PART NO.	MODEL	PART ASSY	QTY
PBY-5A		28F5400-1	
PBY-5		28F5001

A8
NAVY NONE
-6 & -7 Z-P & NOTED
HEAT TREAT
FINISH
DRAFT
NAME INSTALL.- FURN.-WATER STILL & STOVE - STOWAGE
GRP HAND
J 28F5402

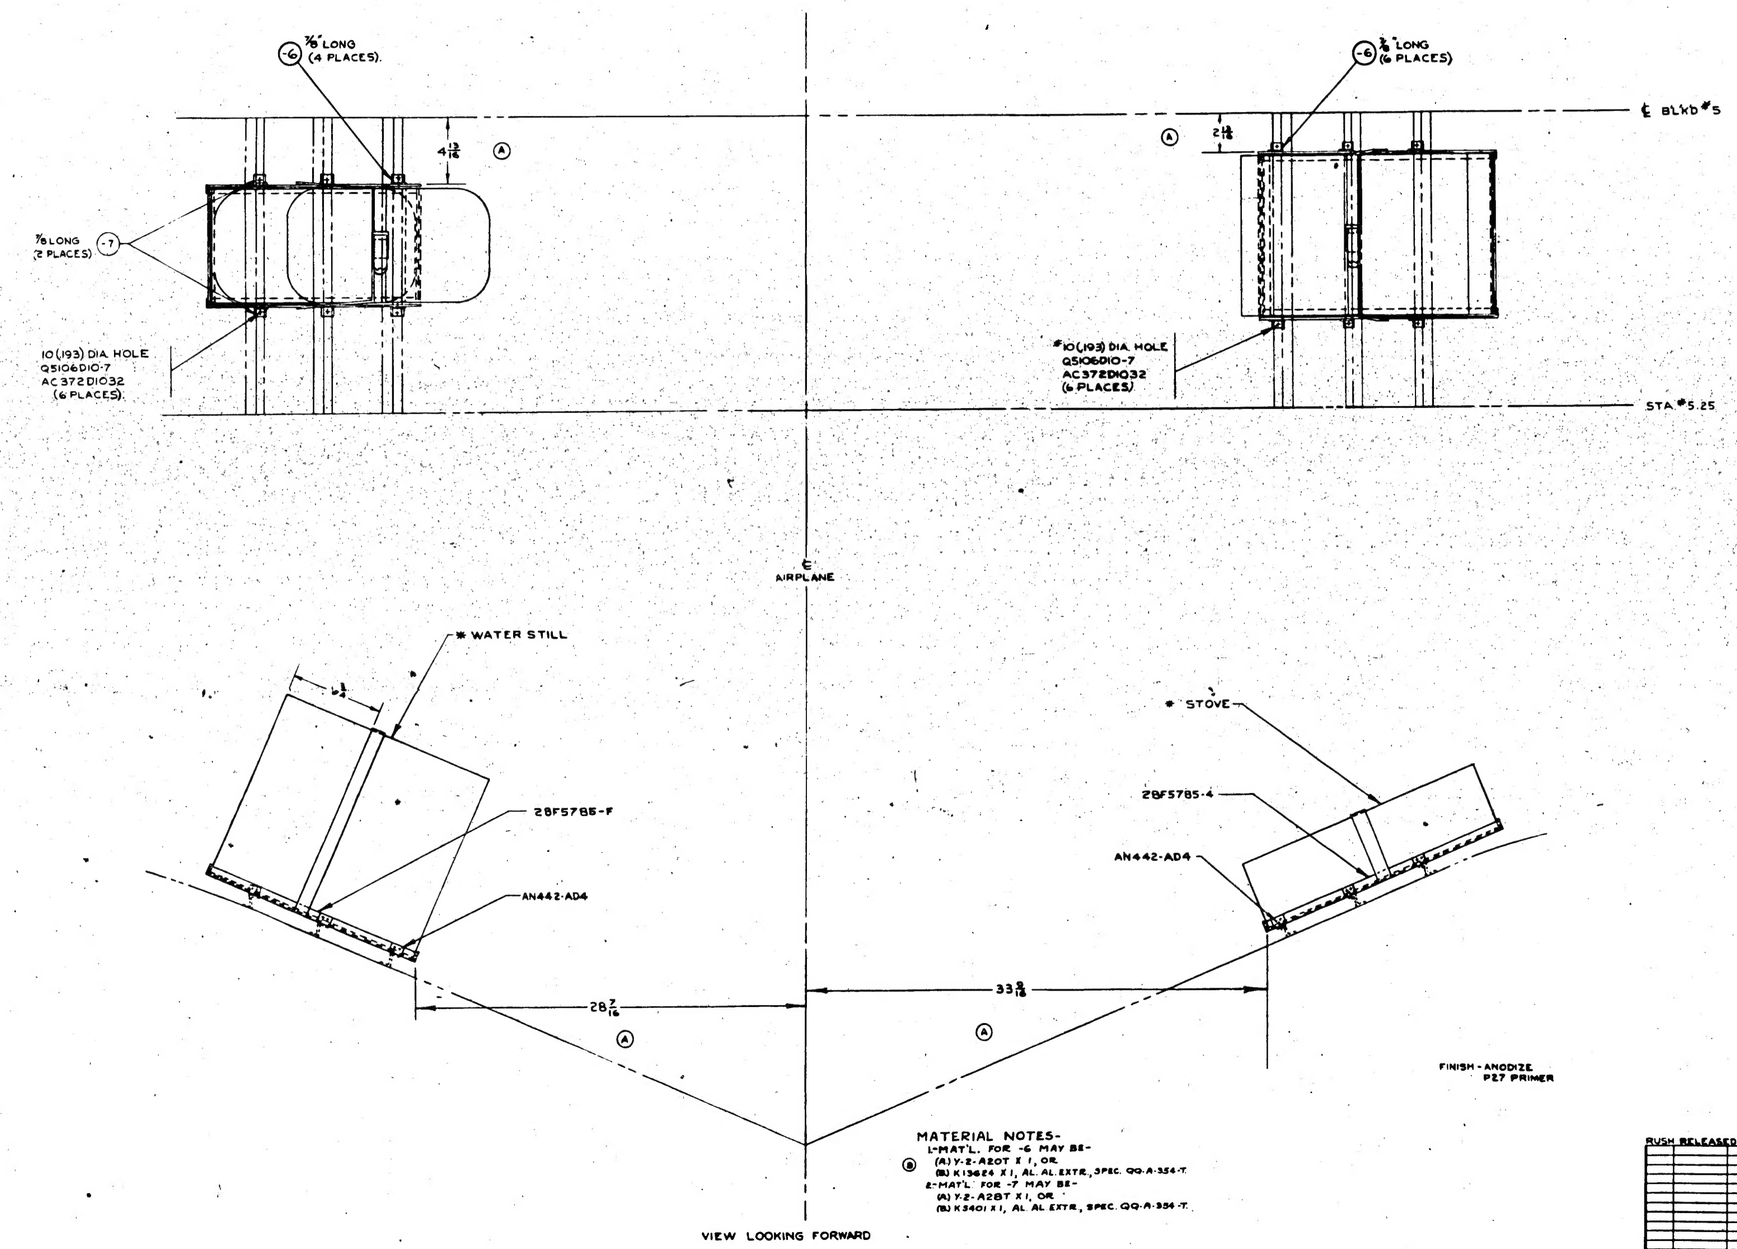
LET	ALTERATION	DATE	BY
A	TRACED & DETERMINED POSITION OF HOLE & MARK-6 WELL. ADD 1/16 TO 2-3/16 & 33 3/16 WAS 33 1/16. 4 IN. WAS 3 15/16. ADD 1/16 TO HOLE. NO VOL CHG.	1-22-43	
B	[illegible]	[illegible]
